Document ID: IK1400033
Revision: 1
Created: 3/24/2014
Last Modified: 7/7/2014
Author: Pablo Guerrero

Title: Torque change for 5/8 inch rear axle shaft flange mounting stud with cone locks and flat washer type hardware.

Applies To: 1652, BE 200, CE 200, CE 300, FE 300, RE 200, RE 300, 4100, 4200, 4300, 4400, 5500i, 5600i, 5900i, 7300, 7400, 7500, 7600, 7700, 8500, 8600, 9200i, 9400i, 9900i, CT630, CT610, Prostar.

Figure 2 (Torque Sequence)

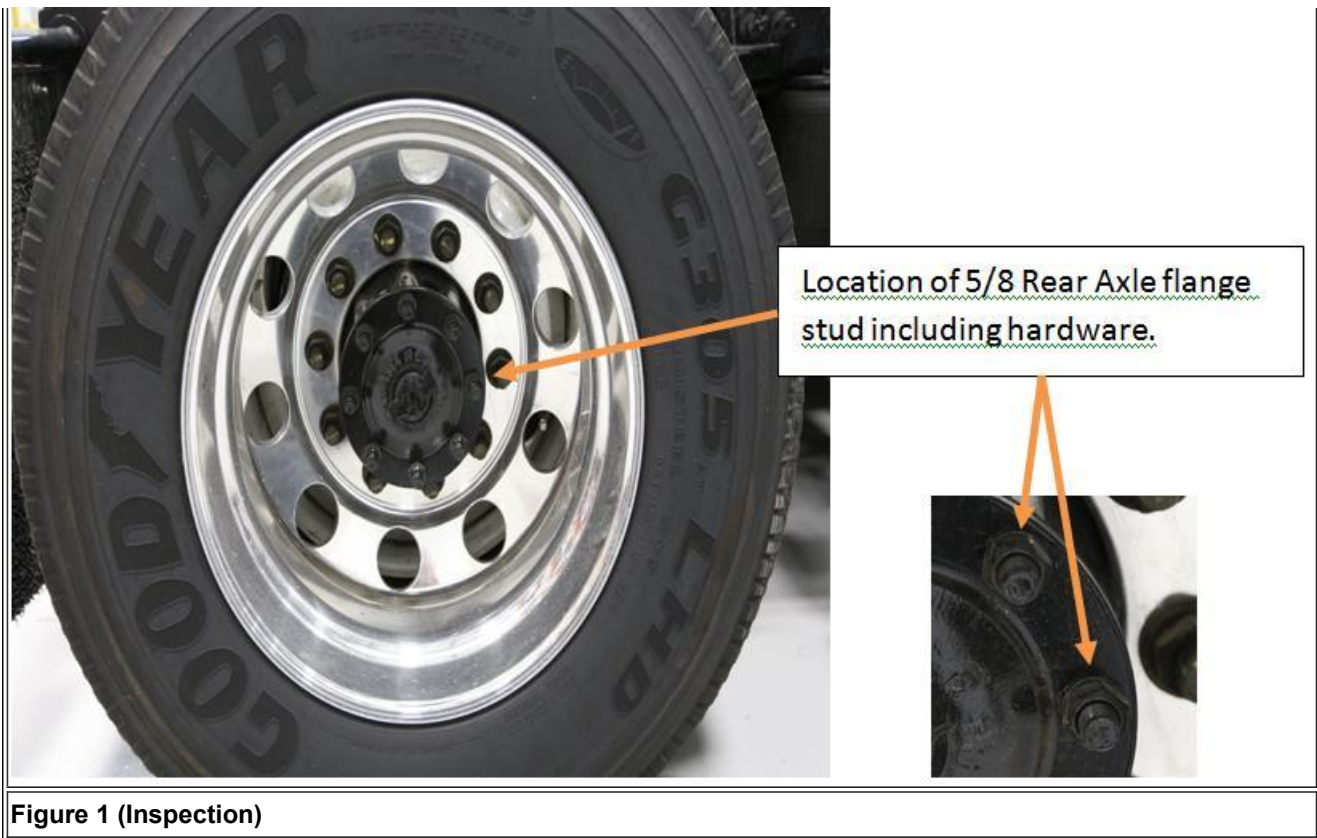
The required torque for 5/8 inch rear axle shaft flange mounting stud hardware has been increased. Torque has been increased to 145 - 175 ft*lbs with both cone lock and flat washer type hardware . This will address the issue of missing or loose 5/8 studs, and leaking gaskets.

- 1) Inspect for missing or loose 5/8 axles shaft hardware (Figure 1).
- 2) If any loose or missing hardware is found, replace missing 5/8 rear axle flange hardware
- 3) Re-torque all 5/8 rear axle flange hardware to 145 - 175 ft*lbs using correct torque sequence (Figure 2)

NOTE: For 5/8 inch ONLY rear axle shaft flange mounting stud hardware All 5/8 Rear Axle Flange hardware (cone locks or flat washers) are now torque to the same higher value of 145 - 175Ft*lbs
